SAFETY RECALL

Sr07-10

DATE : FEBRUARY 2008	SECTION : 07
SUBJECT : ZF-ASTRONIC AUTOMATIC TRANSMISSION GEAR SHIFTER PAD DEFECT

FIGURE 1: H3 COACHES

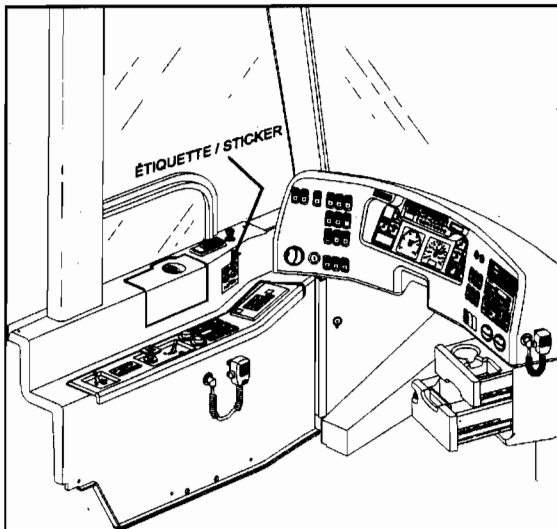
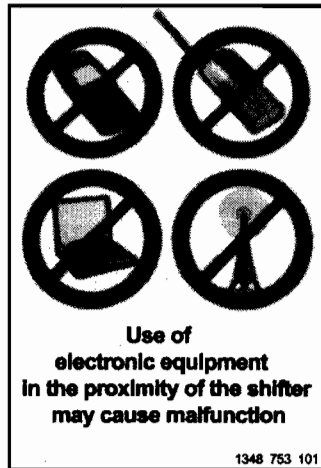
1. Check and confirm that the radio installation is in accordance with the radio supplier's installation guidelines.
2. Affix the sticker onto the L.H. side of the gear shifter pad as per figures 1 and 2.
